# SKEP III Home Office Support Site Visit Report

Consultant	Wahib Medanat Consultant Engineer	Rep No.	22-16062022
Contractor	Dijlah Establishment Constr. Contracting	Tender No.	(11/2019/USAID/SKEP/3/S) Schools for a Knowledge Economy Project (SKEP) - Phase (3) Package (1, 2)
Site Name	Thahr Al Sarow Basic School for Boys- Jerash	Day/ Date	Wed. 16/06/2022
Duration of Project	450 Calendar Days	Total Project Budget	8,314,983.735 JD

(Figure: 06)

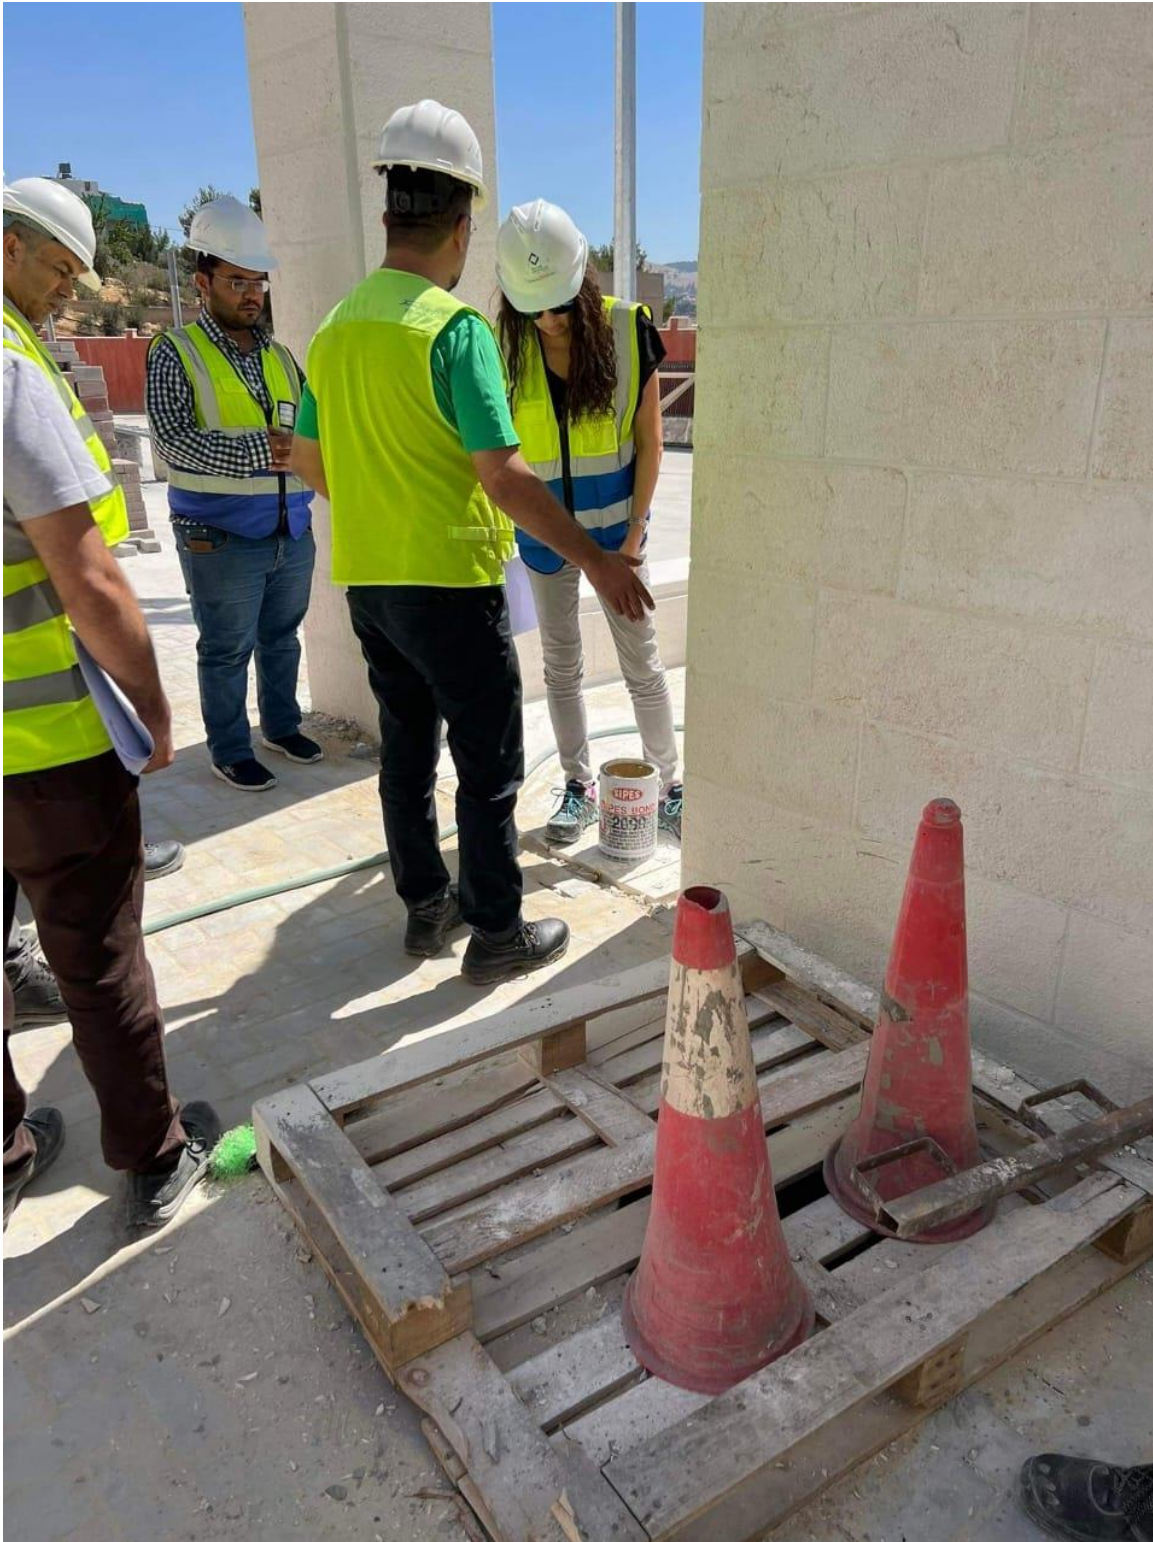
Complete removal of the built defected stones for the front façade

(Figure: 20)

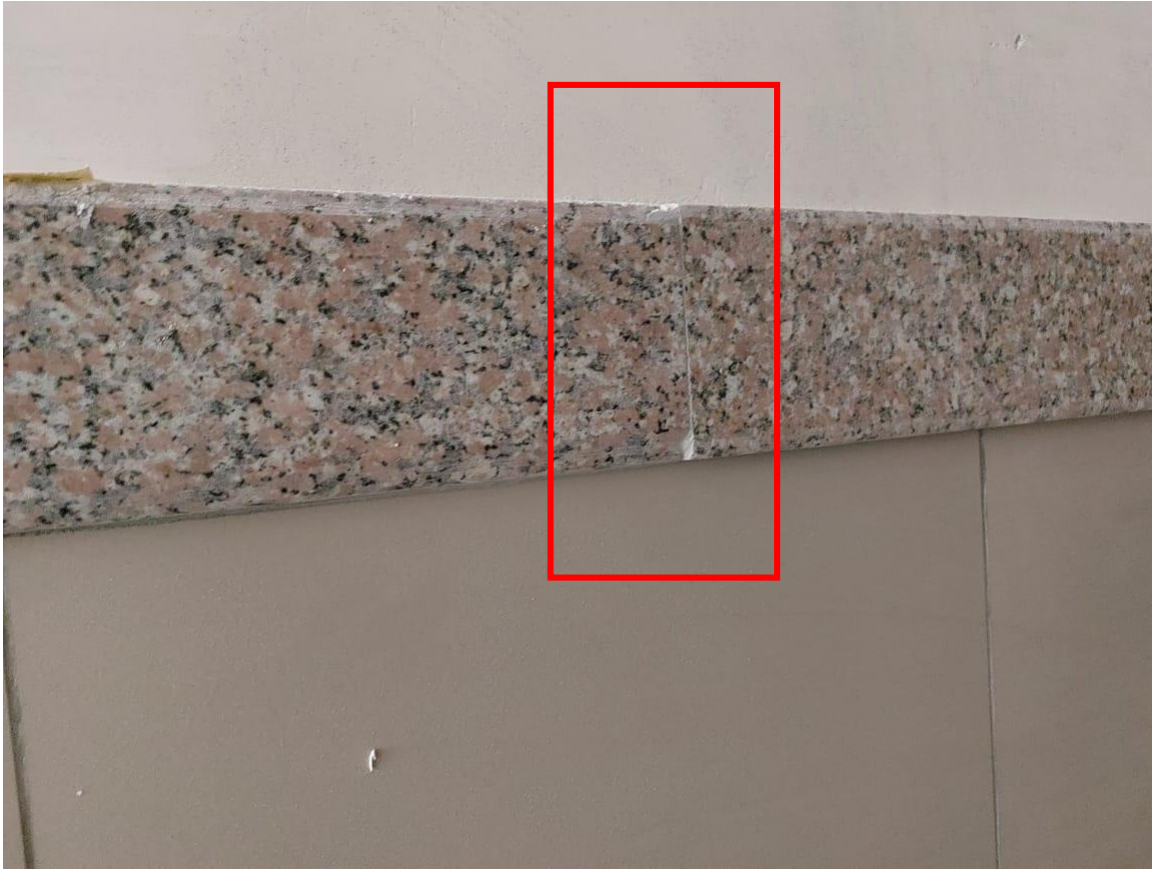
The team inspected the installed granite for the elevator's door frame and observed protrusion at the corners and requested the Contractor to rectify
